SEWAGE DISPOSAL SYSTEM
HOWARD COUNTY HEALTH DEPARTMENT
BUREAU OF ENVIRONMENTAL HEALTH
410-313-2640

P 515220

A REPAIR

SUBDIVISION _____ LOT NUMBER _____ ADDRESS 14350 Dorsey Mill Road

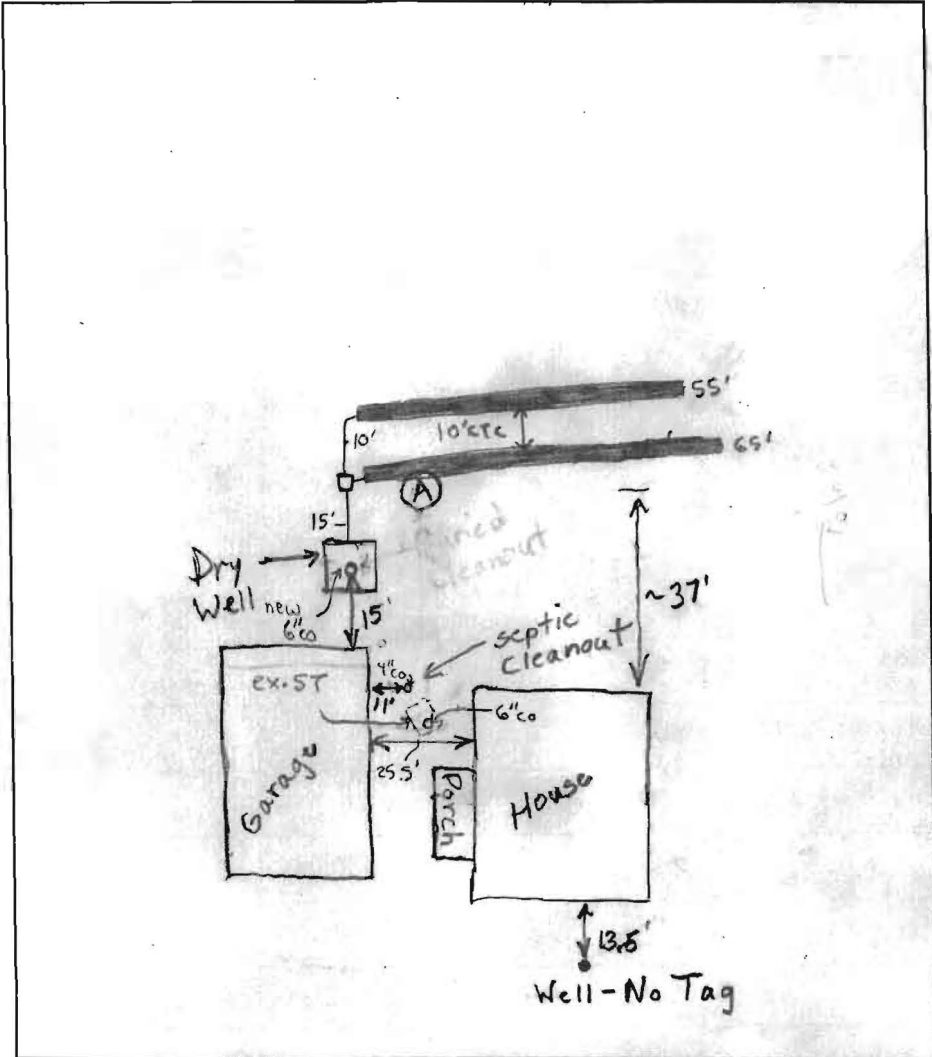
Dorsey Mill Road
 PRE-CONSTRUCTION INSPECTION: 4/27/01 From 55' branched. Inlet 5.5', bottom 10.5'

To set distribution box from drywell (BB)

INSPECTION COMMENTS: 4/30/01-INSTALLER PLACED NEW PVC BAFFLE IN DRYWELL,
OK TO COVER ALL WORK - (SRK)

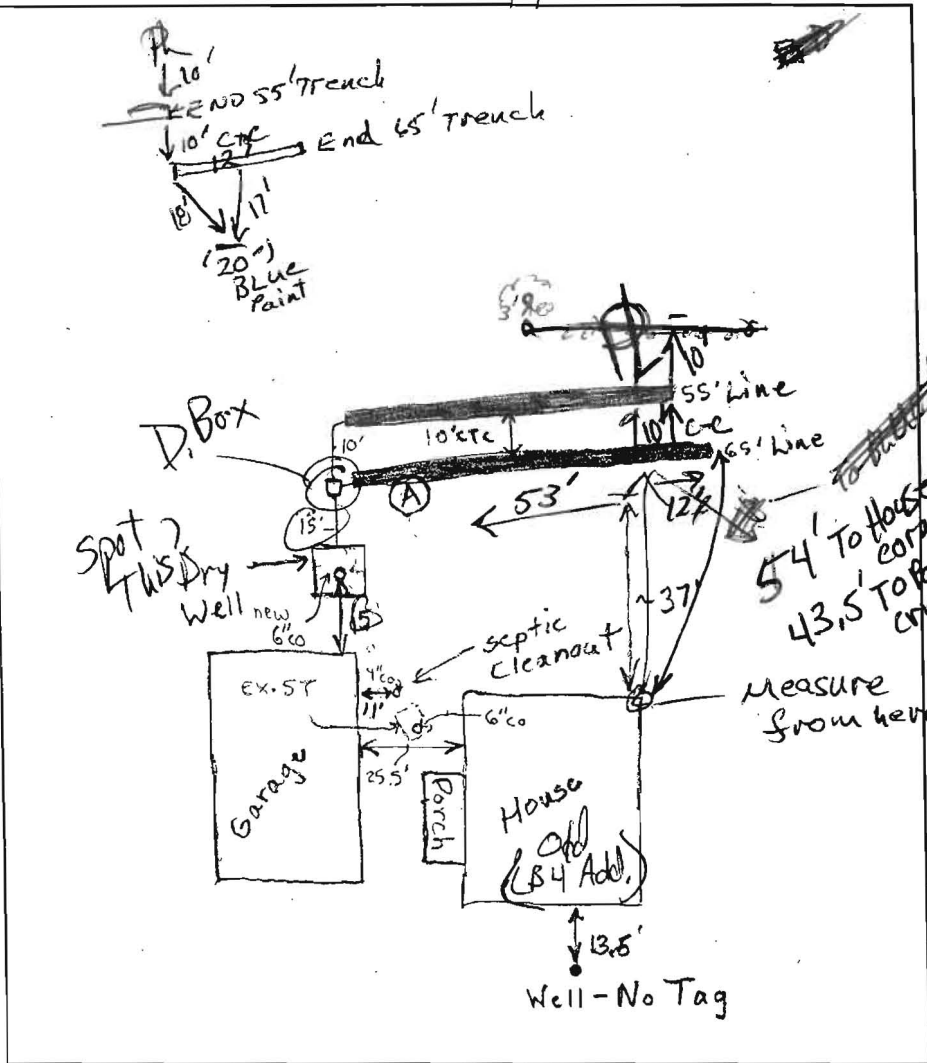
Dorsey Mill Road
 PRE-CONSTRUCTION INSPECTION: 4/27/01 Two 55' trenches. Inlet 5.5', bottom 10.5'

To set distribution box from drywell (BB)

INSPECTION COMMENTS: 4/30/01-INSTALLER PLACED NEW PVC BAFFLE IN DRYWELL,
 OK TO COVER ALL WORK - (SRK)

LOCATION DIAGRAM

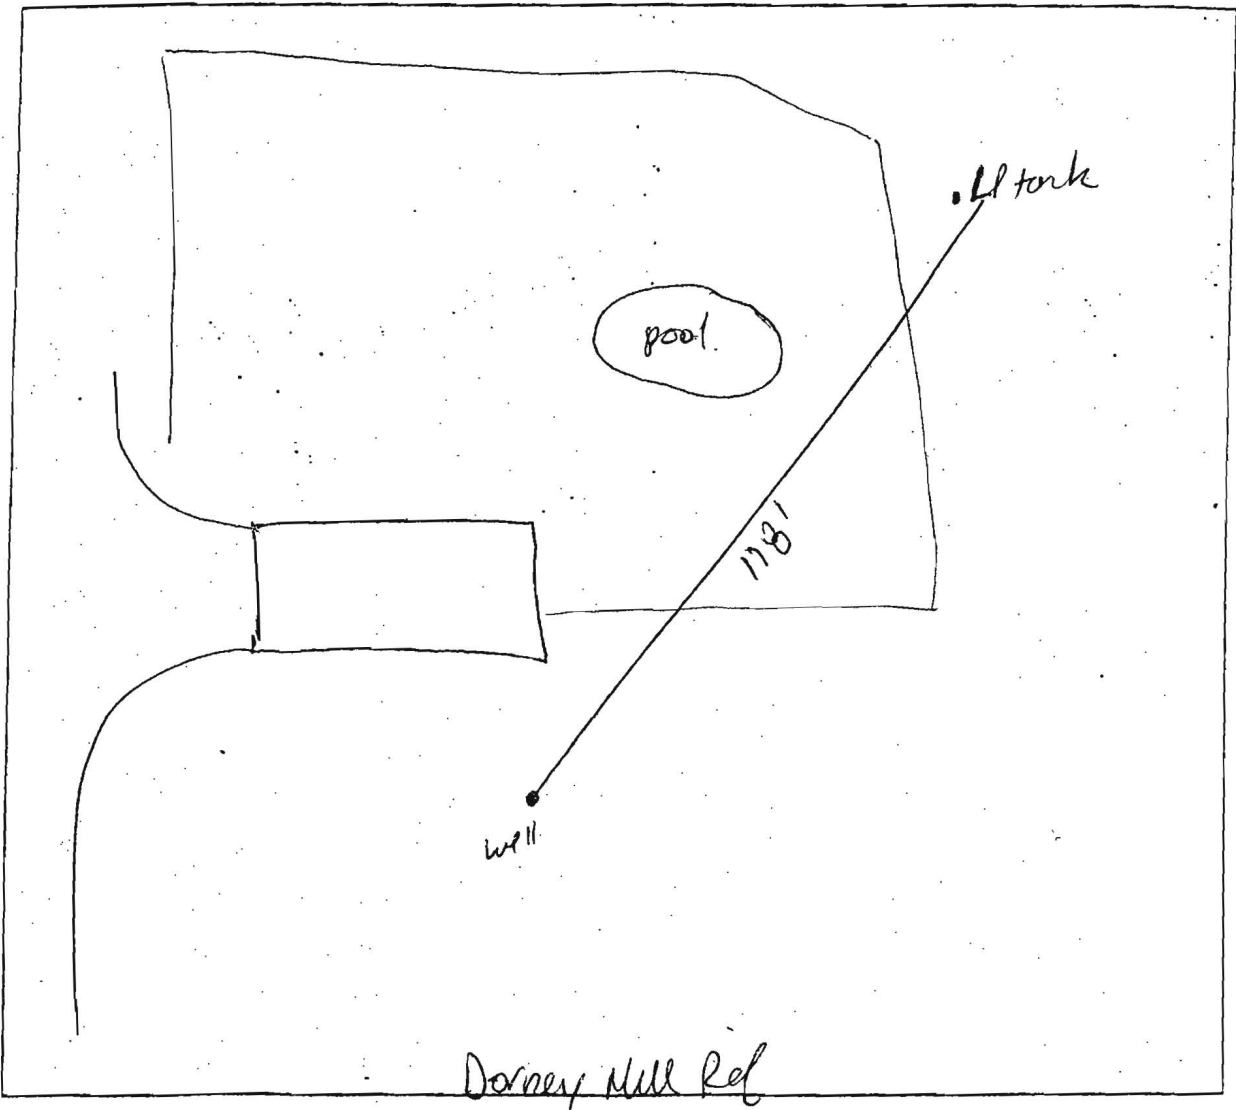
PROPOSAL: verify distance from well to propane tank

COMMENTS: not back from well to propane tank okay.
